Product Change Notice

JENSEN® JE5015

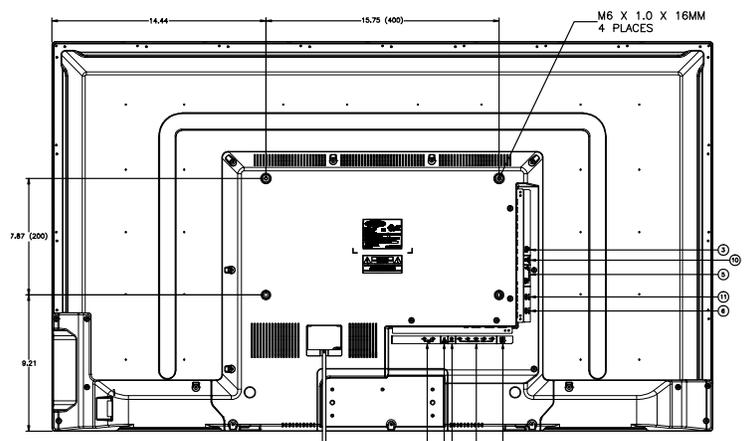
The JENSEN® JE5015 will be changing to a different VESA configuration. Televisions with a "P" at the beginning of the serial number will have a 400 x 200 VESA pattern instead of the traditional 200 x 200 VESA pattern. This change will be effective immediately.

- Please note there are no changes to the cabinet.
